REMEDIATION SYSTEM EVALUATION

**MODESTO GROUNDWATER CONTAMINATION SUPERFUND SITE
MODESTO, CALIFORNIA**

Report of the Remediation System Evaluation,
Site Visit Conducted at the Modesto Groundwater Contamination Superfund Site
July 19, 2001

Final Report Submitted to Region 9
December 10, 2001

FIGURE 1-1. SITE LAYOUT SHOWING THE WELLS AND THE PCE PLUME AS DETERMINED BY THE NOVEMBER 2000 SAMPLING RESULTS.

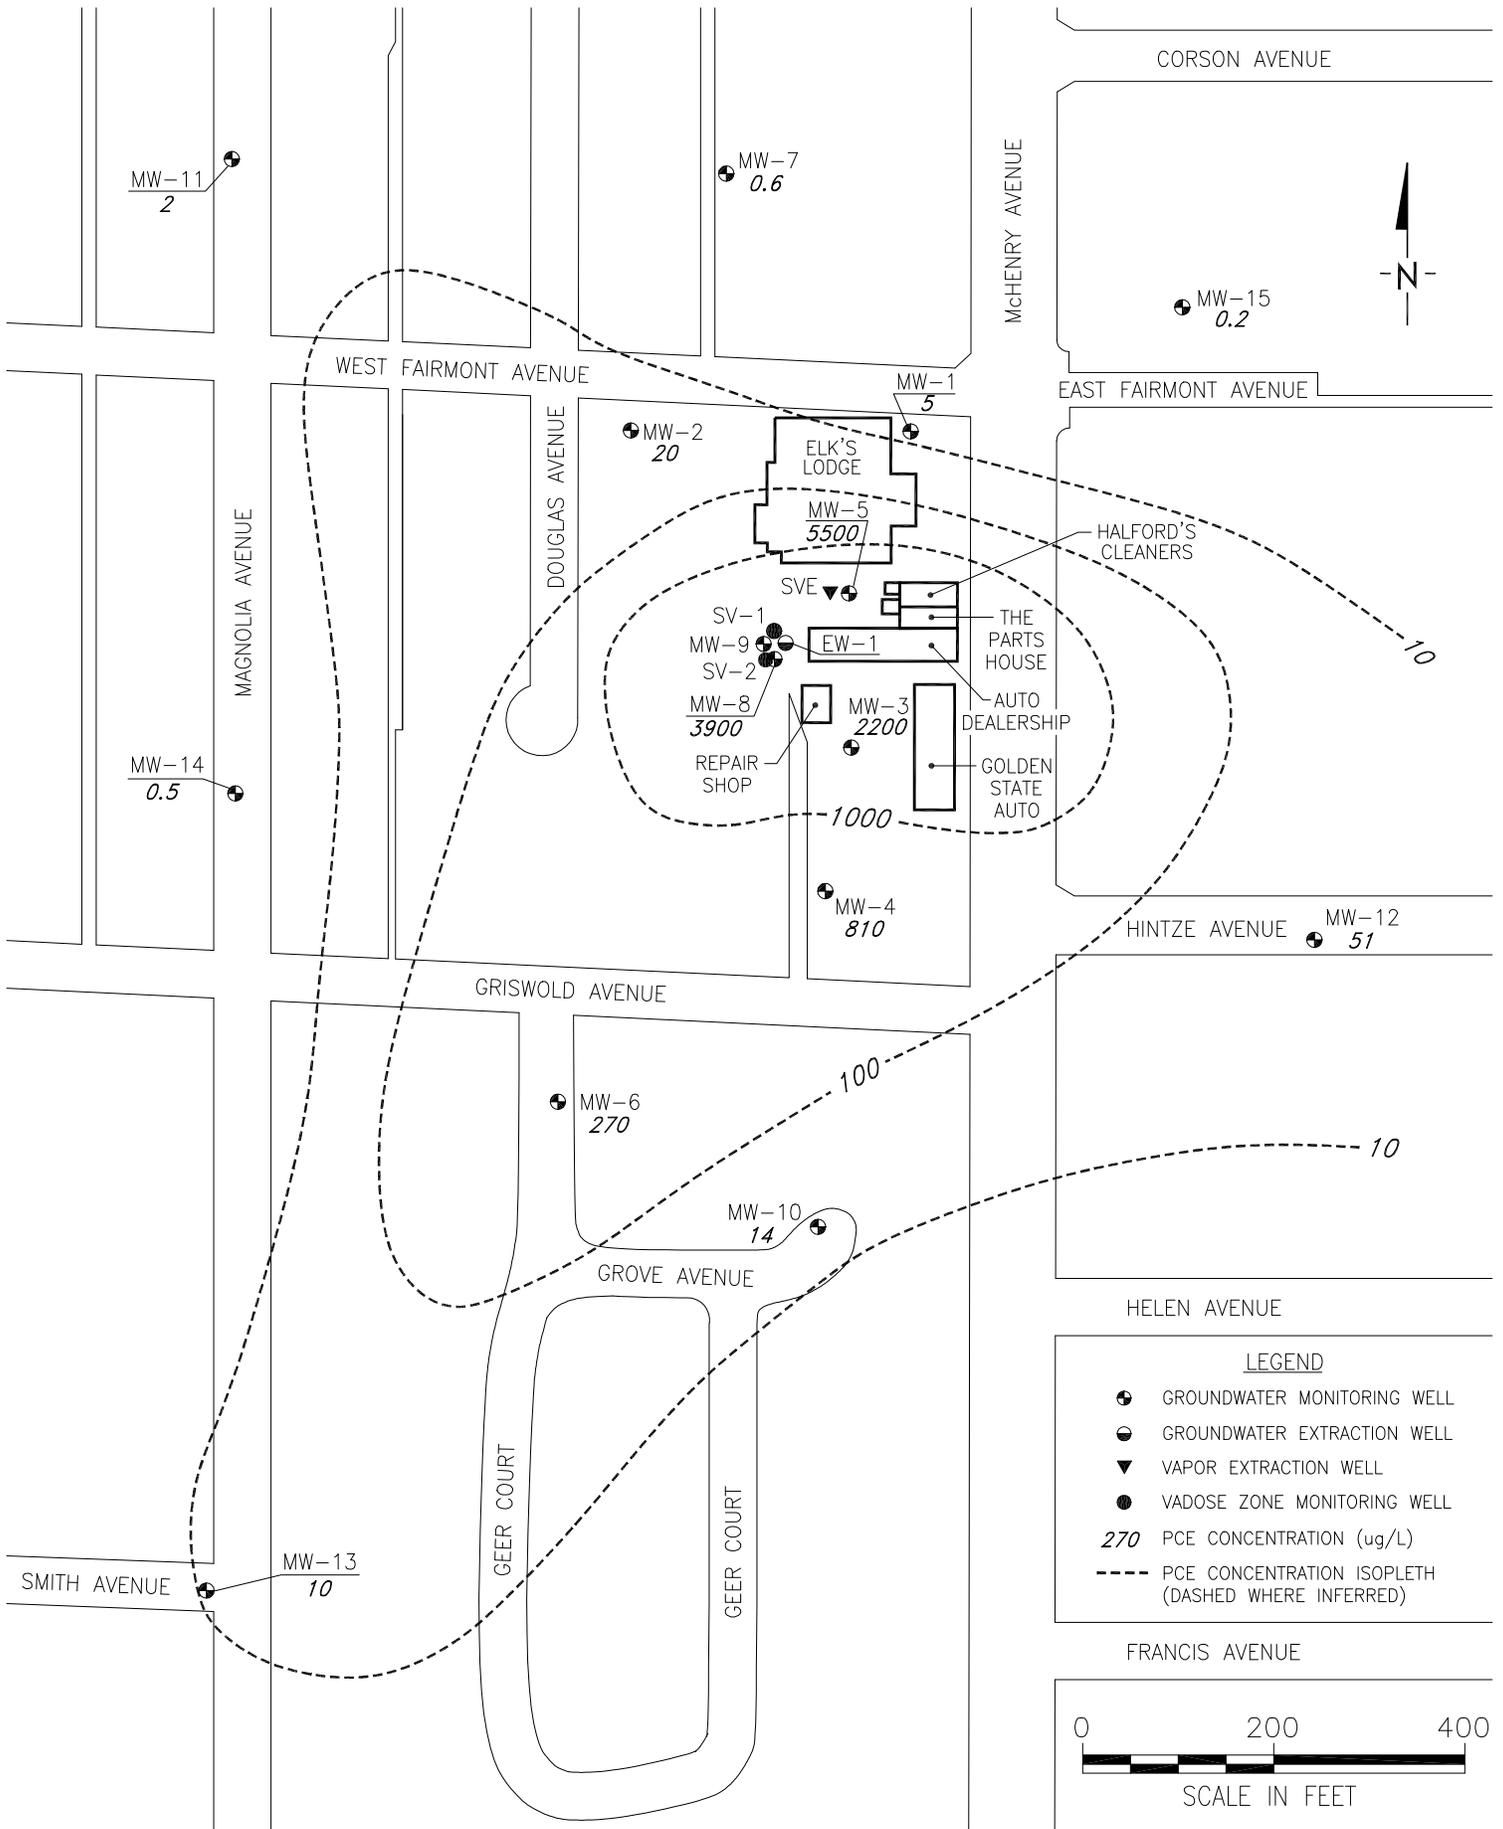
- PCE concentrations to the southeast and southwest had extended beyond the outermost monitoring wells as of November 2000. In addition, in August 1999 the concentration in the deeper aquifer had increased by an order of magnitude suggesting downward migration of the contamination. Continued migration may be occurring in these directions, and additional monitoring wells

downgradient of this portion of the plume may be necessary to accurately delineate the plume if concentrations in the present monitoring wells in these areas do not decrease.

The highest concentrations of PCE center around Halford's Cleaners and diminish in all directions as the distance from the cleaners increases. PCE concentrations in the monitoring wells adjacent to the site and above 95 feet bgs (MW-3, MW-5, and MW-8) range from 2,200 ppb to 5,500 ppb. Over time, and in the absence of pumping from Well 11, the plume has spread to the south. Approximately 300 feet to the south of the site (MW-4) the November-2000 PCE concentration was 810 ppb and approximately 600 feet south of the site (MW-6) the November-2000 PCE concentration was 270 ppb. PCE concentrations in monitoring wells to the north (upgradient in the absence of pumping from Well 11) are 20 ppb or lower and are likely residuals from periods when Well 11 was operating. PCE contamination has extended below the fine-grained layer that extends from 95 to 145 feet bgs as revealed by samples taken from MW-9. The concentrations, however, are two orders of magnitude lower than those in MW-8 which is adjacent to MW-9 but over 50 feet above it. A plume map is provided in Figure 1-1.

Although a capture zone analysis has not been performed since the modeling study conducted in 1997, a comparison of the plume maps from 1997 and April 2000 suggests no appreciable horizontal spreading of the PCE plume or increases in the sampled concentrations of the shallow monitoring wells. Rather, the PCE concentrations in the monitoring wells near the source area decreased, suggesting limited dilution of the source area. The PCE concentrations in the deeper well (MW-9), however, did increase by an order of magnitude between April and August 1999. It should be noted that before August 2000 the SVE and pump-and-treat systems were not operational. PCE sampling results from November 2000, after a three month test period of the SVE and pump-and-treat systems, are similar to those obtained in April 2000 with the exception that PCE concentrations in the monitoring wells near the source area were higher (more comparable to those obtained in 1997). Thus, it appears that the plume area has not increased appreciably over a three year period even in the absence of pumping. The magnitude of PCE concentrations in the deeper monitoring wells, however, have increased significantly.
